## **Addendum No. 3**

**Park Ranger Facility Renovations**

**Bid # 6122**

**DeCarlo & Doll, Inc.**

DATE: 5.22.2015 SKA-1

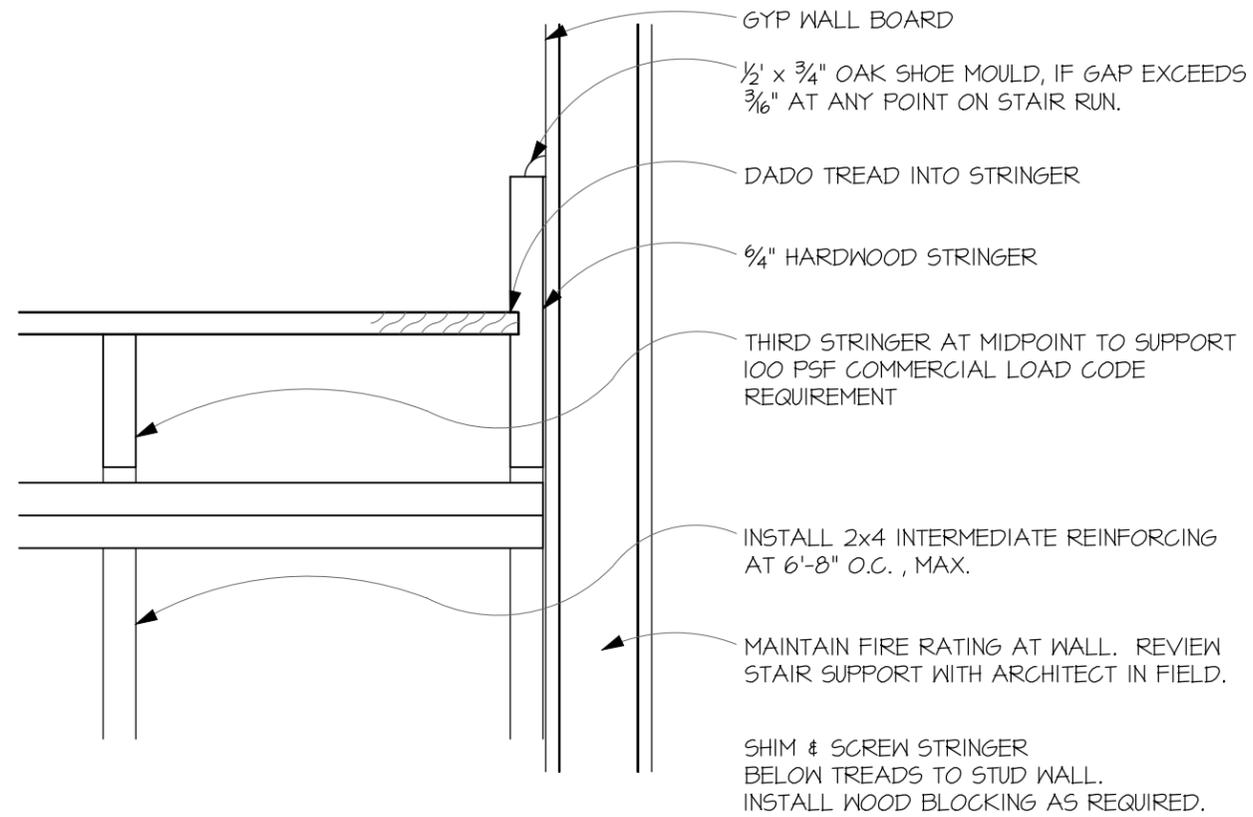
Addendum 3 consists of the following 4 Heading Topics ('A' through 'D') noted below. There is a total of 6 answers and clarifications noted under Headings below. REVISED BID FORM, SKA-1 STAIR DETAILS and SKA-2 STAIR & MECHANICAL SHAFT FRAMING PLANS are attached to this Addendum.

SCALE: 1/4" = 1'-0" DRAWING NO:  
DATE: 5.22.2015 SKA-2

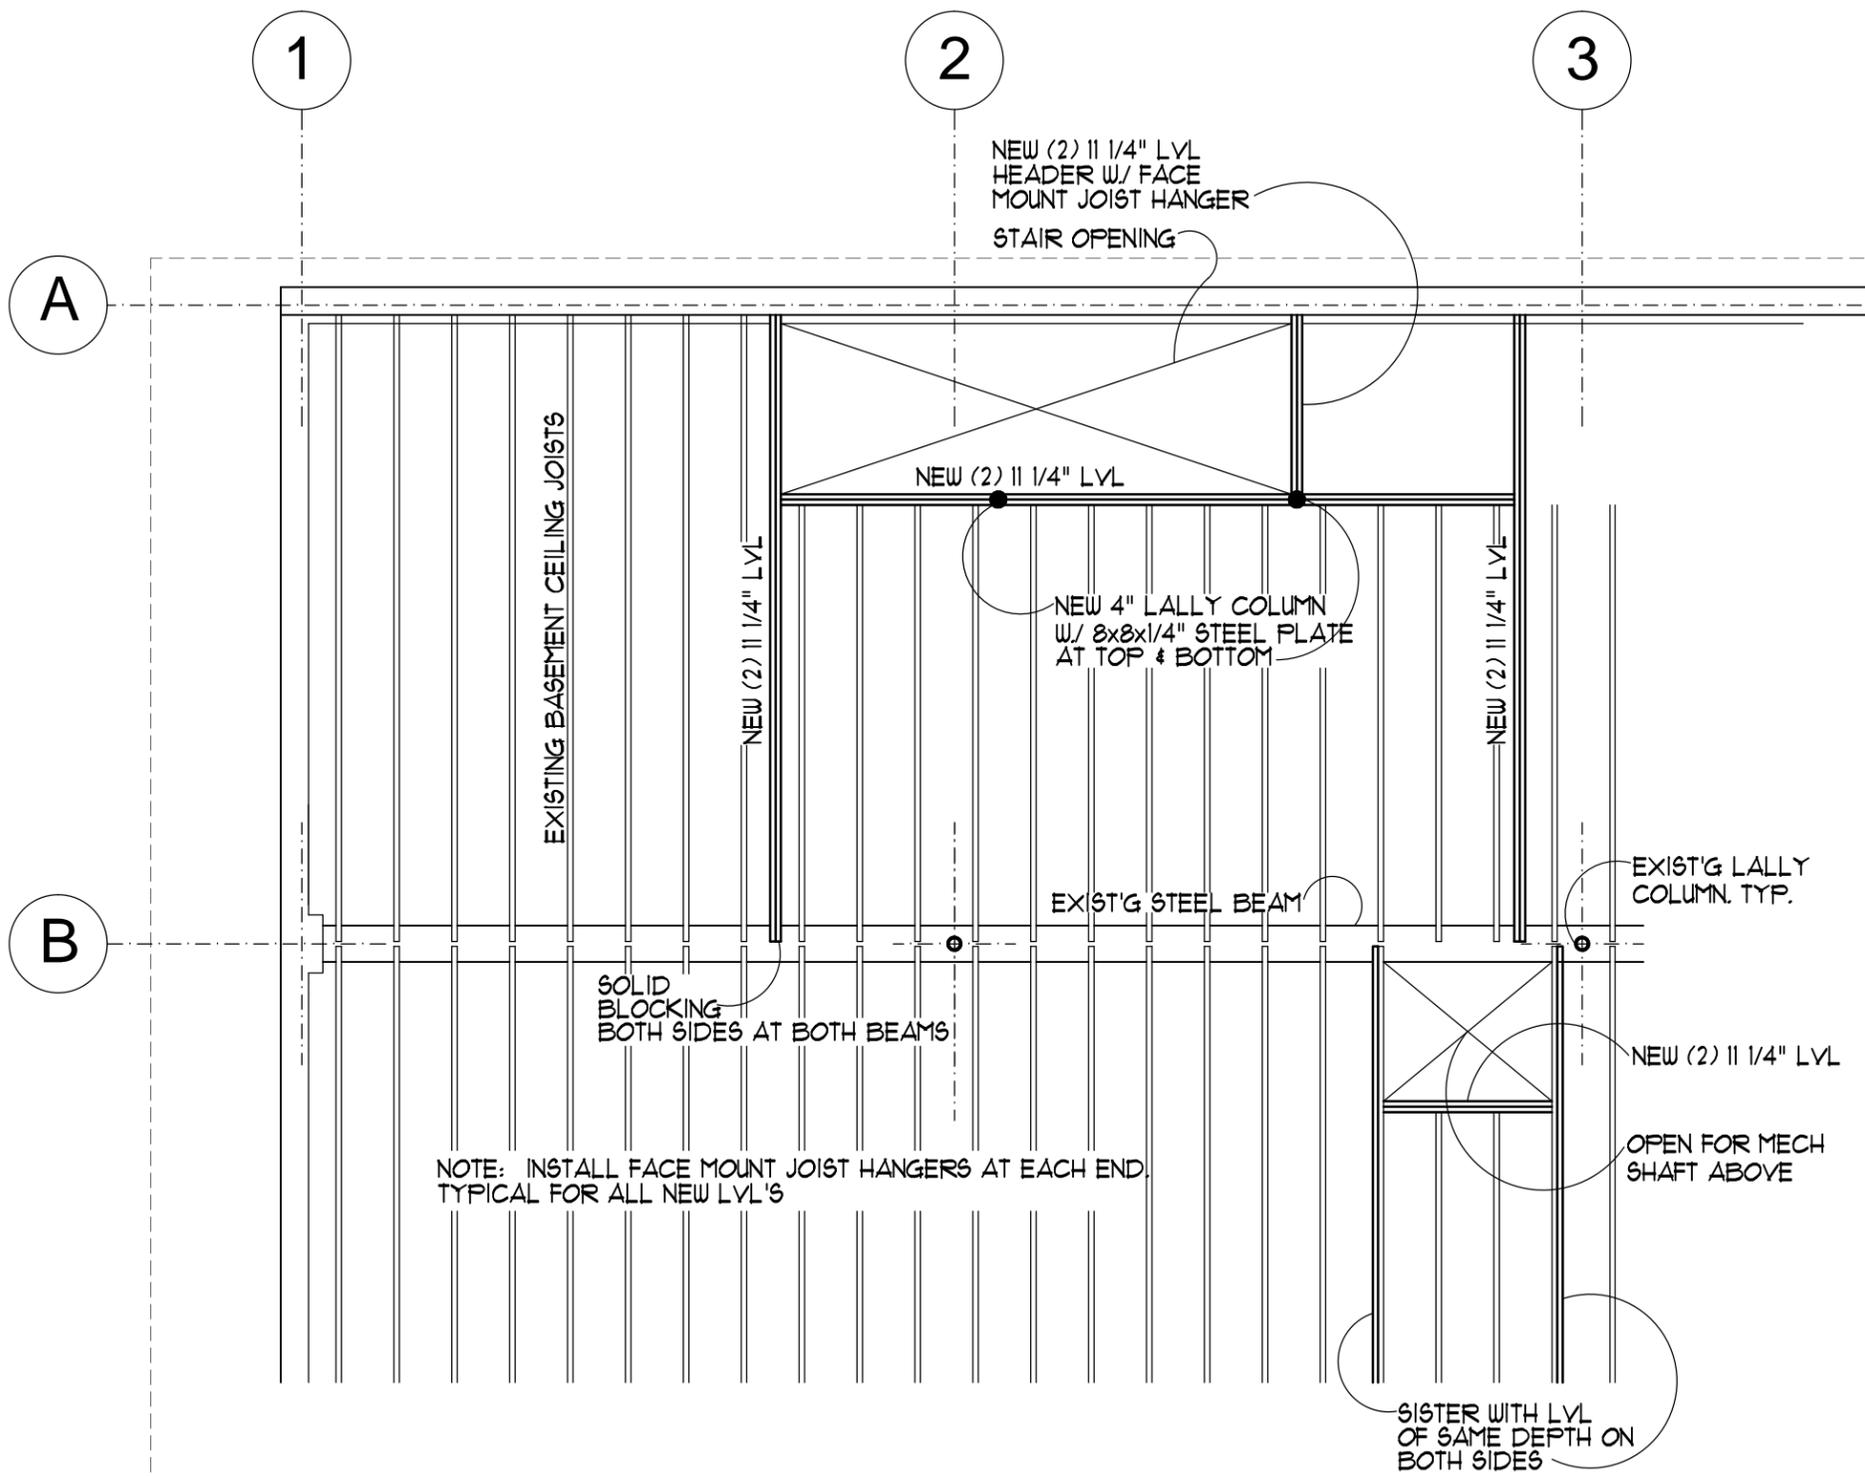
6. Contractors are to carry an ALLOWANCE for new concrete work consisting of cutting existing concrete Basement Slab at 2 locations under new lally columns (shown on SKA-2 attached,) and pouring 2 new concrete footings – 18"x18"x12' deep.

7. SKA-2 – FRAMING PLAN, supersedes Addendum 2, Paragraph 15, letter 'I'. Bid per SKA 2. DELETE Addendum 2, Paragraph 15-I.
